TRANS/WP.29/GRE/2002/3
23 January 2002

World Forum for Harmonization of Vehicle Regulations (WP.29)

PROPOSAL FOR DRAFT AMENDMENTS TO REGULATION No. 65

Transmitted by the Experts from France and Germany

Annex 2, add the following examples of approval marks:

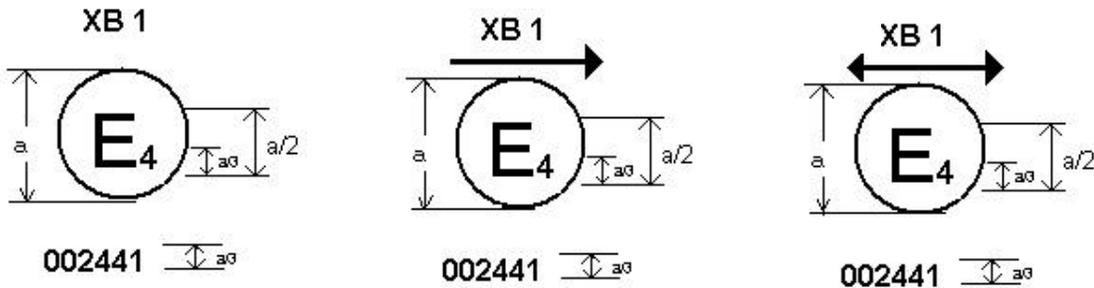
- a special warning lamp indicates that it has been approved in the Netherlands (E4) under approval number 002439. The approval number shows that the approval was granted in accordance with the requirements of the Regulation in its original form and that it is a blue colour rotating or stationary flashing special warning lamp of class 1 (TB 1).
- a directional flashing lamp indicates that it has been approved in the Netherlands (E4) under approval number 002440. The approval number shows that the approval was granted in accordance with the requirements of the Regulation in its original form and that it is amber colour directional flashing lamp of class 2 (XA 2). **The marking without an arrow indicates that the lamp has a narrow-angle effect.**

- a directional flashing lamp indicates that it has been approved in the Netherlands (E4) under approval number 002441. The approval number shows that the approval was granted in accordance with the requirements of the Regulation in its original form, and that it is a blue colour directional flashing lamp of class 1 (XB 1).

The marking without an arrow indicates that the lamp has a narrow-angle effect.

The arrow indicates that the lamp has a wide-angle effect on the side indicated by the direction in which the arrow is pointing, which also indicates the side of the vehicle on which the device is to be mounted. The double-side arrow indicates that the lamp has a wide-angle effect to both sides, which also indicates that the lamp could be mounted on both sides of the vehicle."

7.3.1. Table of standard light distribution for special warning flash lamp (Category X)

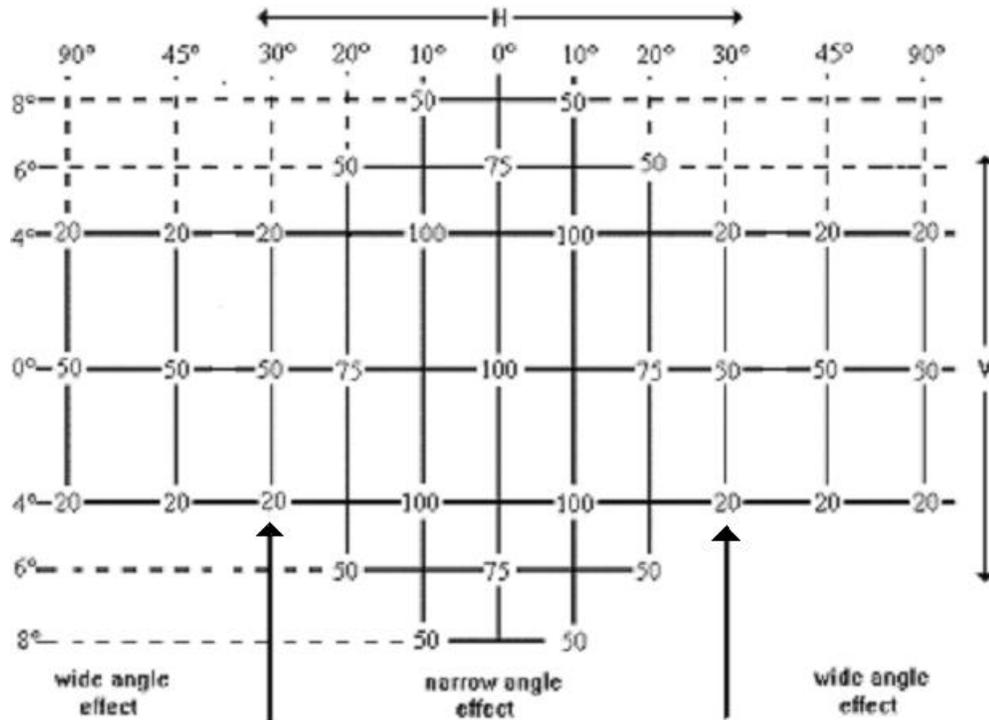
"Minimum horizontal angular range of category "narrow angle effect" is 30° left to 30° right and for category "wide angle effect" 90° directed outwards the vehicle and 30° to the inside.

7.3.1.1. The direction $H = 0^\circ$ and $V = 0^\circ$ corresponds to the reference axis. (On the vehicle it is horizontal, parallel to the median longitudinal plane of the vehicle and oriented in the required direction of visibility). It passes through the centre of reference. The values shown in the table give, for the various directions of measurements, the minimum intensities as a percentage of the minimum required in the axis for each lamp (in the direction $H = 0^\circ$ and $V = 0^\circ$).

7.3.1.2 Within the field of light distribution of paragraph 7.3.1 schematically shown as a grid, the light pattern should be substantially uniform, i.e. the light intensity in each direction of lowest minimum value being shown on the grid lines surrounding the questioned direction as a percentage."
